HISTORIC DISTRICT COMMISSION ADDITIONAL INFORMATION REQUEST

Application Number: HDC2025-00639

NAME: Andre Williams		COMPANY NAME: N/A	
ADDRESS: 949 Chicago Blvd	CITY: Detroit	STATE: MI	ZIP: 48202
PROJECT ADDRESS: 949 Chicago Blvd			
HISTORIC DISTRICT: Boston-Edison

Response to HDC Additional Information Request

PROPOSED REAR ELEVATION

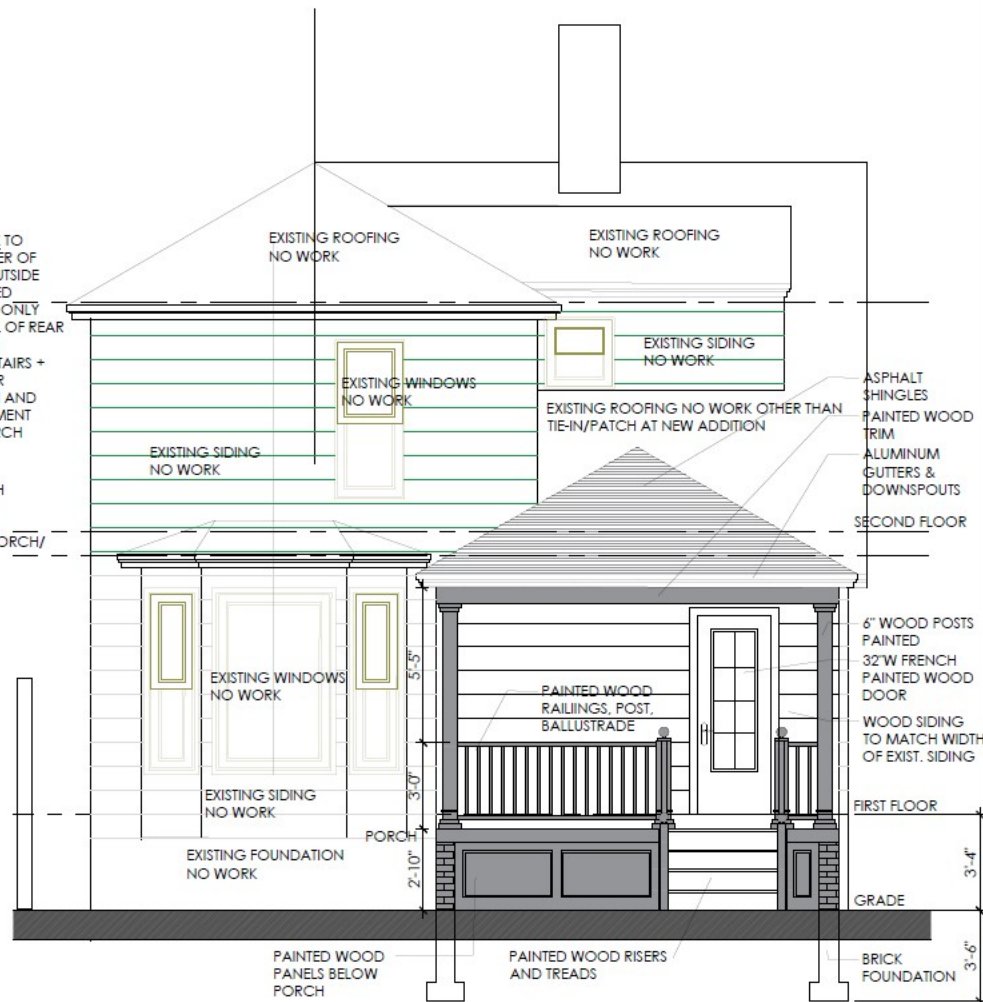
Dimensioned drawings that confirm wall construction/roof (flat roof? Shed roof? Overhanging eaves?) as well as exterior elevation drawings that confirm how this rebuilt structure will look upon completion. Must show all wall trim/mullions/window casings, window operations (as well as glass division: simulated divided lights? Between-the-glass grilles?), etc.

Please note: it is not likely the Commission will approve the installation of cementitious siding/stucco on a rebuilt portion of the historic house. Very likely wood clapboard siding and stucco will be required for cladding materials.

- Proposed Reverse Gable roof, pitched at 9/12, replacing the prior near-flat configuration.
- The new roof design aligns more harmoniously with the existing main house rooflines and gables, reduces long-term maintenance, and improves snow and water shedding performance.
- The reverse gable orientation also visually and structurally complements the HDC-approved garage dormers, creating architectural continuity between the structures.

- First-floor cladding: Hardie Lap Plank Siding with 6" reveal, providing dimensional depth and continuity with the garage finish while maintaining horizontal rhythm.
- Second-floor cladding: Stucco finish consistent with the main house's historic upper wall treatment.
- All exterior trim, window casings, and cornice profiles will replicate the existing historic detailing.
- The **original cornice components** have been **carefully removed, cataloged, and stored** for reinstallation following completion of exterior wall and roof work. Photo attached.

Footing decay

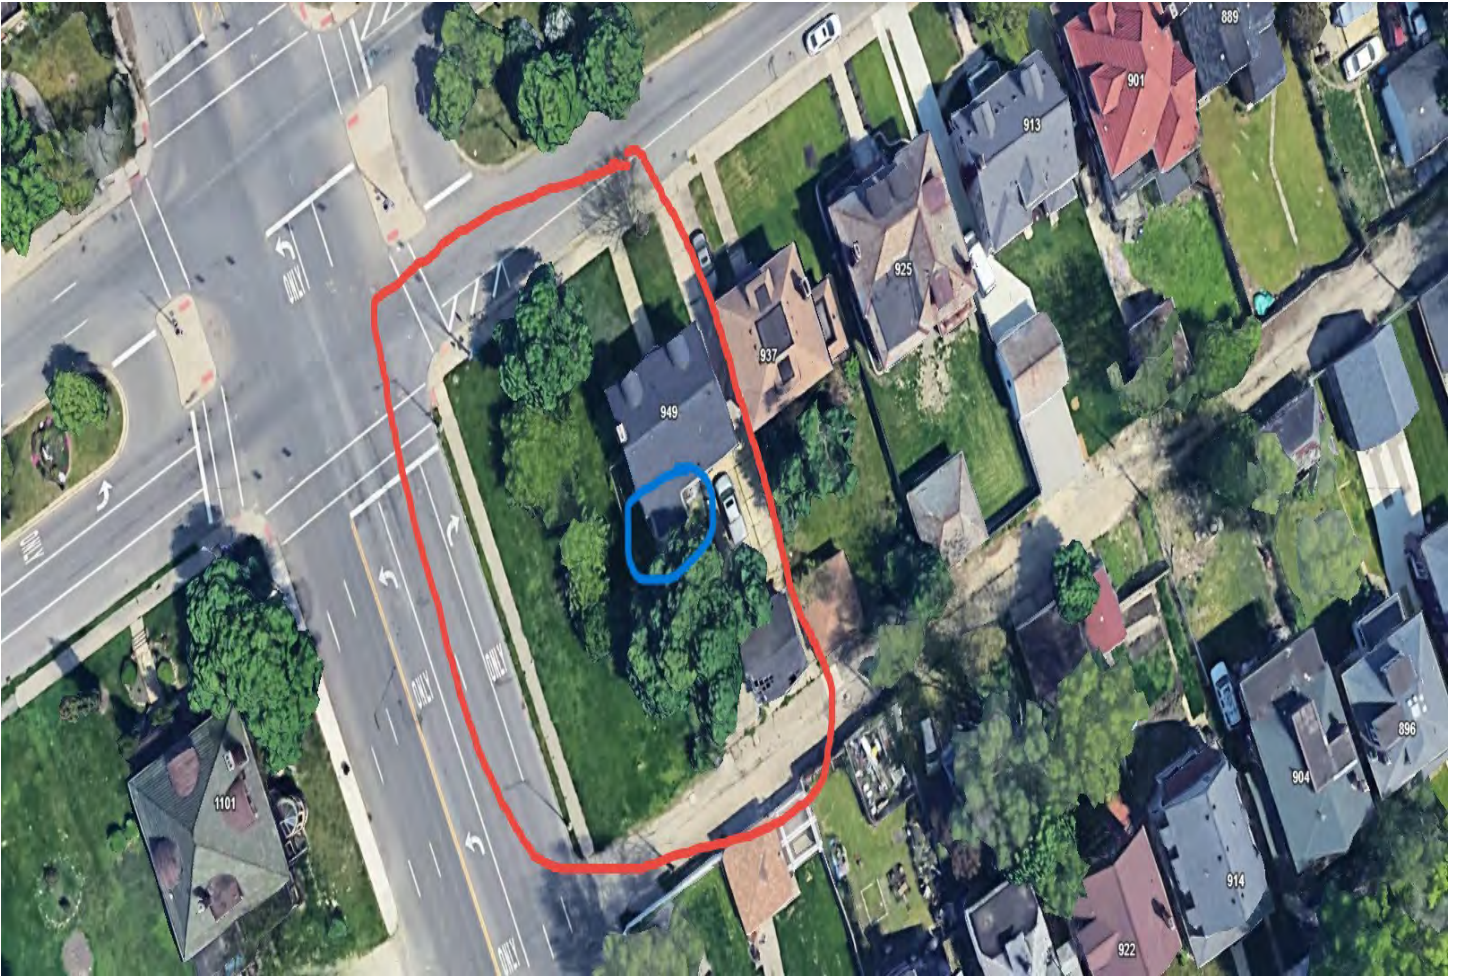
Additional exterior photos are needed (full wall views), of each side of the house and rear extension to understand the architectural styling of the structure and how the rear extension is placed/attached to the house and its current design/condition. Interior photos of the areas proposed for demolition are needed to further illustrate existing conditions. A structural assessment from a licensed engineer is suggested.

- The original brick and cement pier footings had begun to fail from prolonged water exposure and freeze-thaw cycling.
- The primary source of deterioration was chronic water intrusion from the semi-flat roof and inadequate drainage design.

- Please refer to the photographs included in the original submission, which clearly document the unsafe and deteriorated condition of the original footings and flooring that contributed to the structural failure.

SOUTH ELEVATION

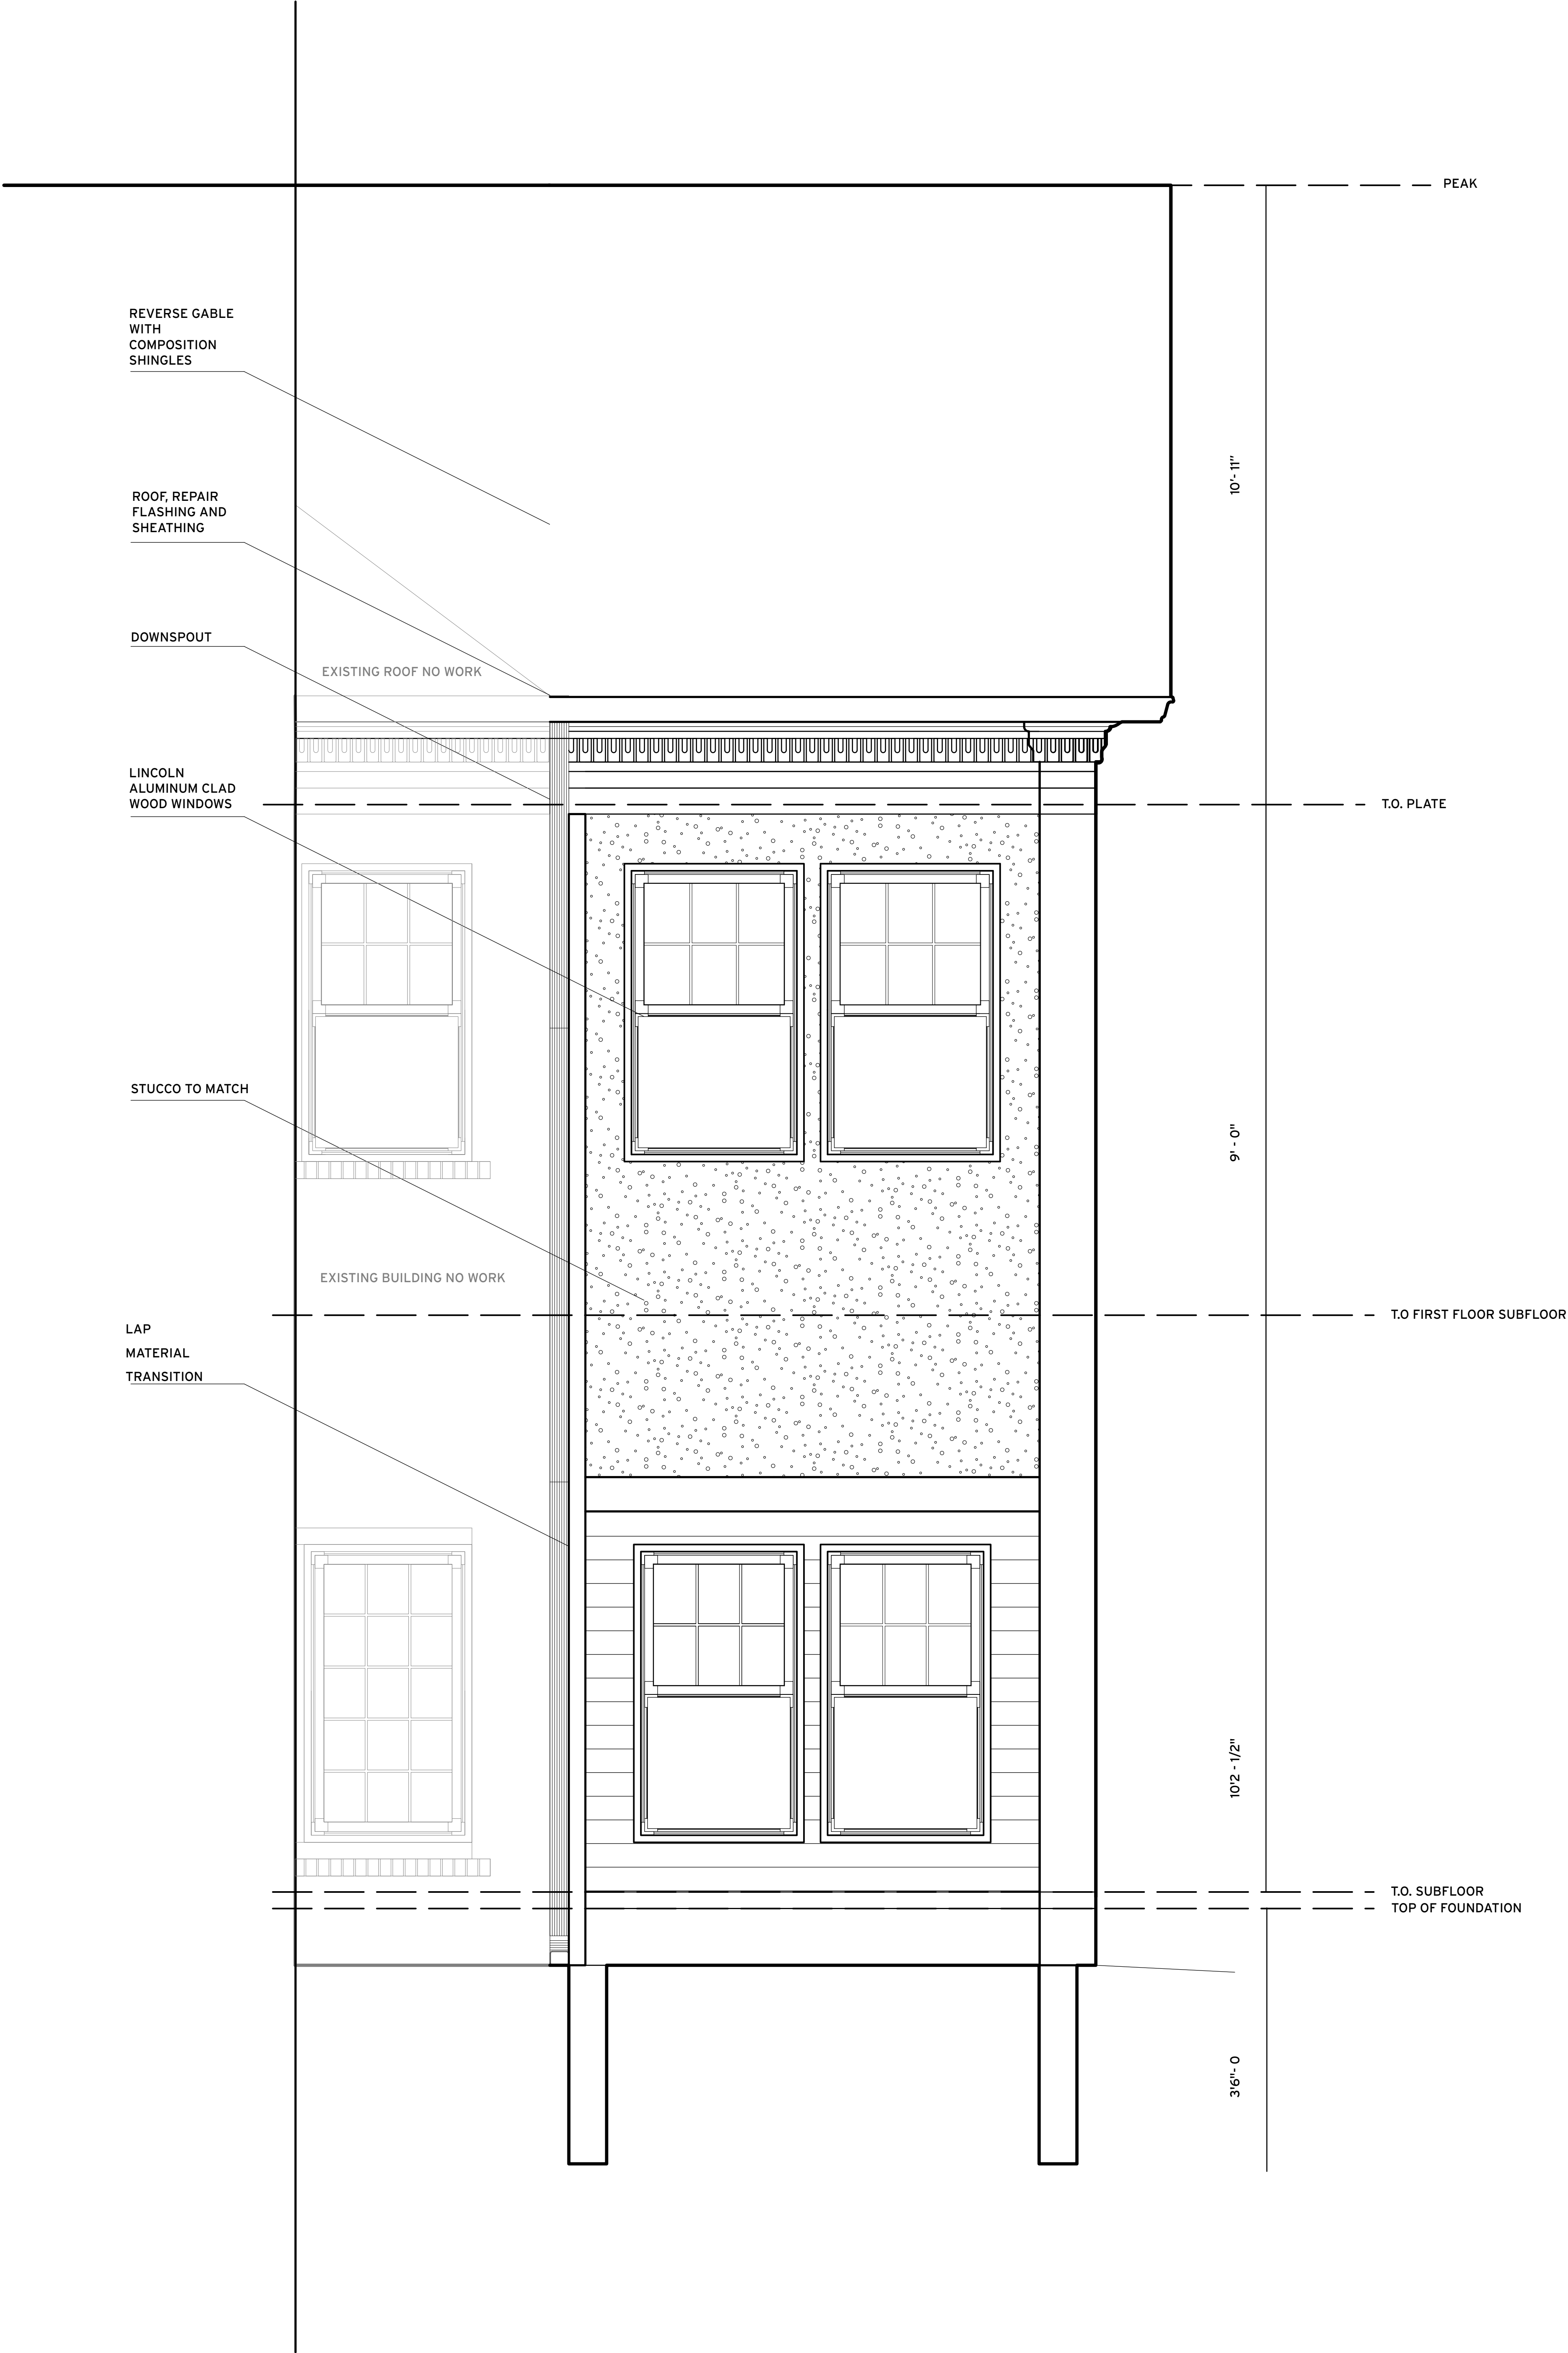
Dimensioned drawings that confirm wall construction/roof (flat roof? Shed roof? Overhanging eaves?) as well as exterior elevation drawings that confirm how this rebuilt structure will look upon completion. Must show all wall trim/mullions/window casings, window operations (as well as glass division: simulated divided lights? Between-the-glass grilles?), etc.

- A dimensioned site plan (based on aerial imagery) confirming the existing house footprint, the rear extension footprint, and the approved garage/outbuilding is included.
- Elevation drawings and sectional diagrams provided to show wall construction, roof geometry (reverse gable, 9/12 pitch, eave overhangs).
- Exterior trim, window and door placement, and finish materials will be clearly shown to illustrate how the rebuilt structure maintains the historic façade alignment and proportion of the original home.
